Access Compliance Report

Public Rights-of-Way

(Curb Ramps)

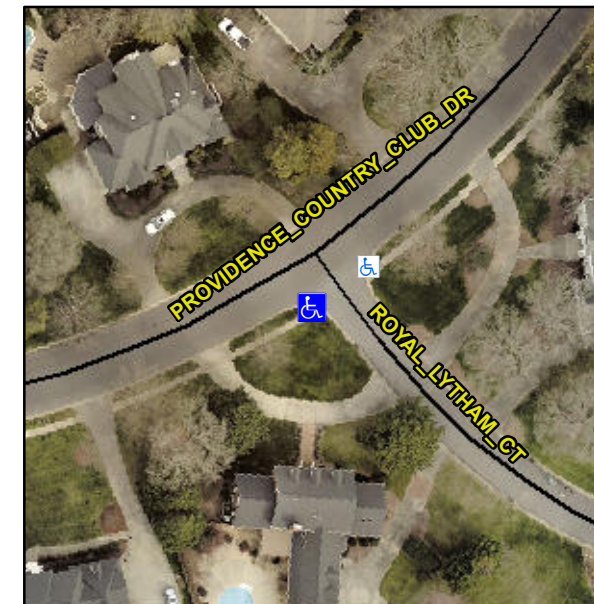
Intersection ID: 27935	Main Street: PROVIDENCE_COUNTRY_CLUB_DR	Cross Street: ROYAL_LYTHAM_CT	Location: SW
ADA ID: AAF16FA84C84	Ramp Type: Perp	Initial Pass/Fail: Fail	Overall Compliance: No
Severity Score: 1.25			
Codes/Mitigation Info/Possible Solution		Field Measurements/Component Compliance

PROW/ADA:

Not Found, R304.5.3

Possible Solutions:

Remove & Replace Entire Ramp.
